Sheet 2 - Mono-tube Boiler Casing - Funnel stub and Funnel

Funnel Stub

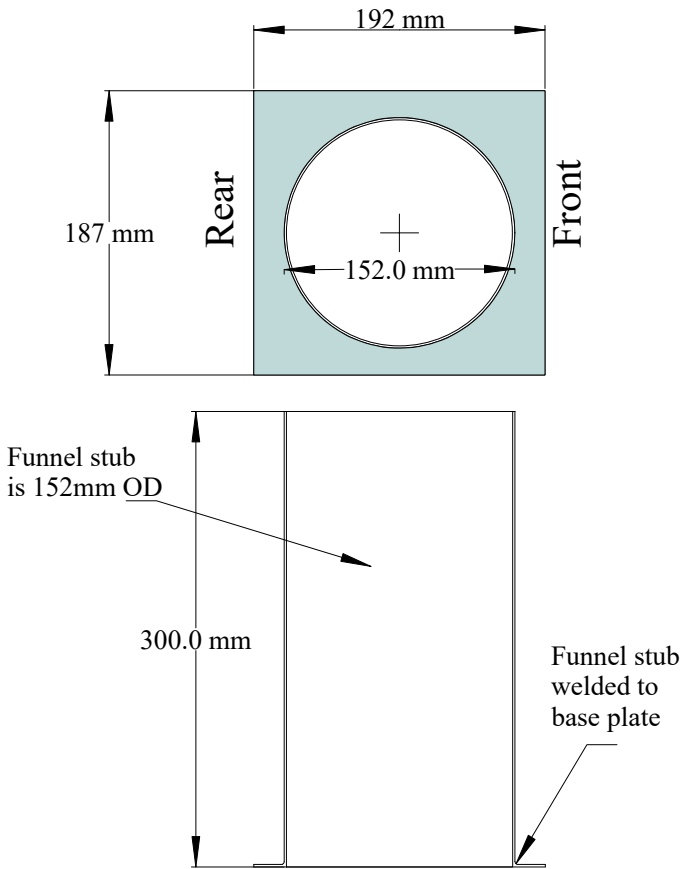
Suggest Funnel stub is 1.2mm sheet.

Funnel Liner

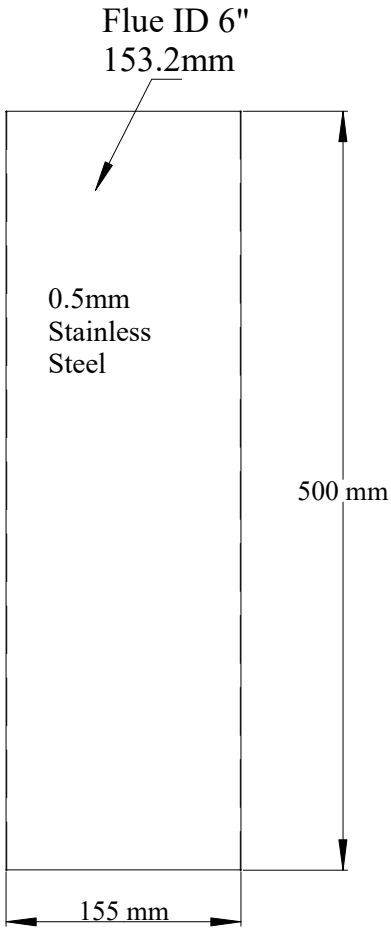
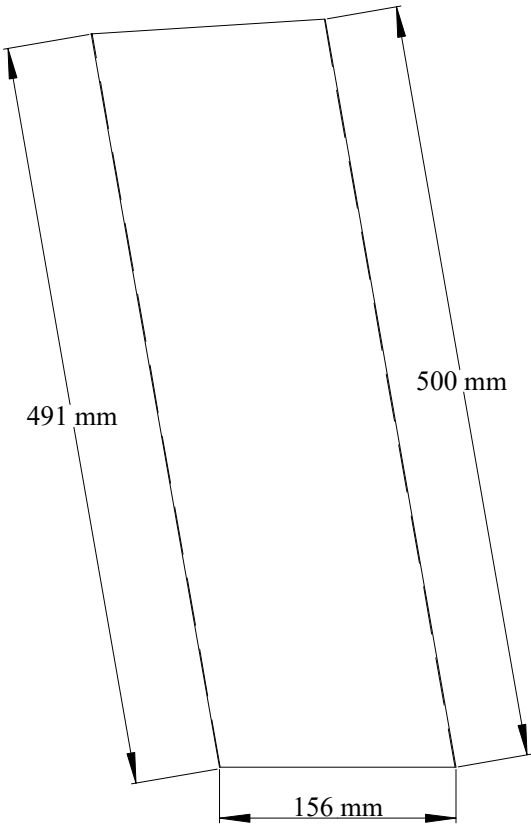
Why a shorter liner? By having the inner shorter than the outer there is some weight saving. An important additional benefit is that it increases the airflow drawn through the holes at the bottom of the outer, making the lower end of the outer cooler and safer for the crew.

The funnel is designed to be double walled with the stainless inner and an aluminium outer. It is drawn to give a 10mm gap between the inner and the outer walls.

Spacers for the joining of the inner and outer can be supplied and fitted by the client if preferred.

The diameter of the outer funnel could be up to 10mm greater if this makes manufacturing easier.
